Appendix A
Revised Supplemental Environmental Assessment
for the Nemadji Trail Energy Center Project
Rural Utilities Service
Summary of Comments on the Supplemental Environmental
Assessment

Supplemental Environmental Assessment for the Nemadji Trail Energy Center Project Rural Utilities Service Response to EPA Comments on the Supplemental Environmental Assessment

Supplemental Environmental Assessment for the Nemadji Trail Energy Center Project Rural Utilities Service Response to MCEA Comments on the Supplemental Environmental Assessment

Figure 1: 2025—2040 MISO West Annual CO₂ Emission Reductions with NTEC

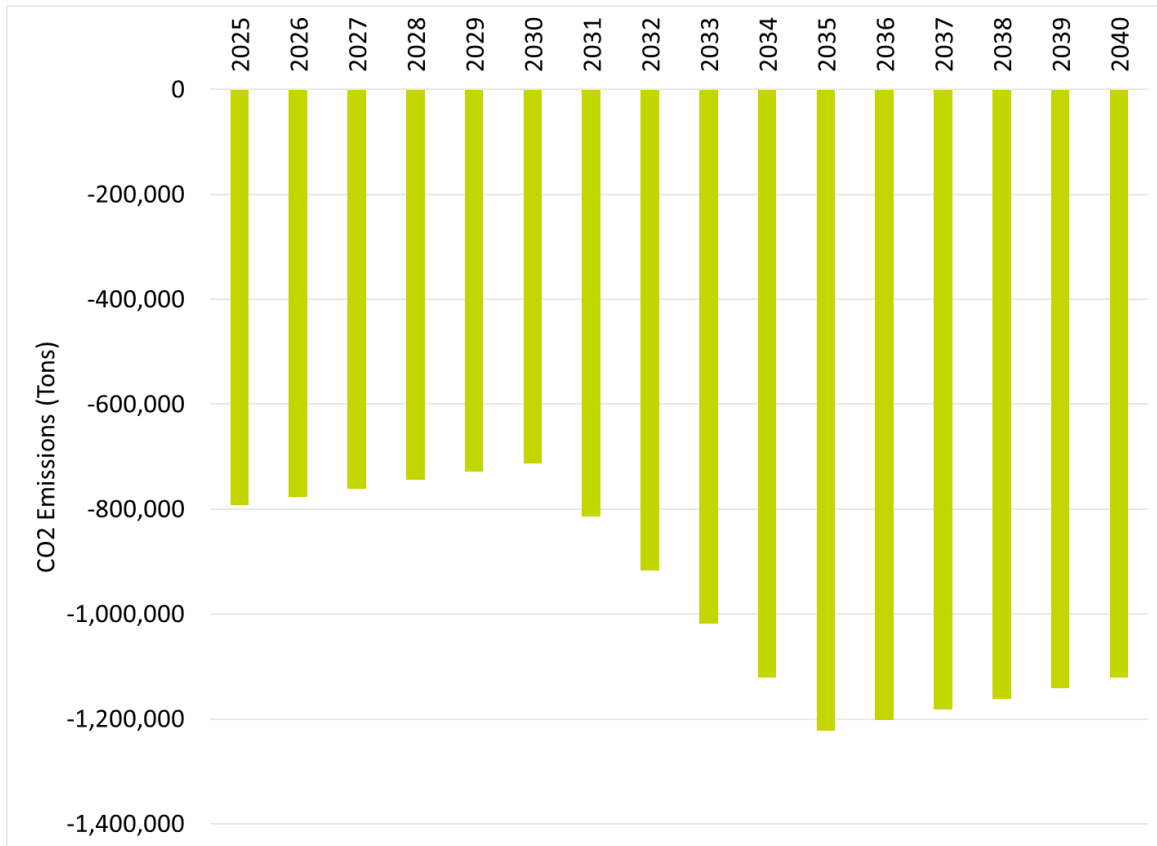
MCEA appears to compare actual GHG emissions from existing facilities in the state of Wisconsin to the maximum potential permitted emissions for the NTEC combined-cycle plant when “ranking” the facilities and their GHG emissions. This is not an apples-to-apples comparison, as comparing maximum permitted GHG emissions for all facilities would result in a much different comparison of emission sources in the state.

NTEC will be among the most efficient fossil-fuel generating resources in the MISO West. It can be expected that NTEC will continue to displace less efficient fossil-fuel generation past 2040 even if more efficient facilities than NTEC are introduced into the system (*See* Figure 1 below from the production cost modeling (Appendix B of the SEA)).

In every year modeled for the Proposed Action (aka “with NTEC”), the model shows emissions reductions. Further in the final years modeled, the model continued to show over one million tons of reduced emissions. It is also reasonable to expect that the NTEC facility will reduce emissions over its operational life because it is expected to operate less frequently if renewable resources are operating and able to meet energy needs in the area. In the MISO markets, generators are dispatched based upon their marginal price. That price is almost exclusively influenced by fuel and variable operating expenses. As a result, NTEC is expected to displace generators that also burn fossil fuels. MISO uses economic dispatch, which will run low or no variable cost (renewable) resources prior to those that have a fuel cost associated with producing electricity, such as NTEC. Thus, the Project is anticipated to continue to displace any lesser efficient coal and natural gas resources, even beyond 2040 and will be available as a reliability insurance policy when there is insufficient renewable resources to meet system electric demand, enabling Dairyland to incorporate additional renewable resources as presented in Chapter 1 of the NTECEA. Thus, the Project is anticipated to continue to displace any lesser efficient coal and natural gas resources, even beyond 2040. As noted in the *Governor’s Task Force on Climate Change Report*,³² Wisconsin is anticipated to experience an increase in peak energy demand by 2024, so increasing grid flexibility is “critical to manage customer costs and minimize environmental impact if the system peak continues to increase” (page 35). NTEC will increase grid flexibility by providing an efficient dispatchable energy source to increase reliability during
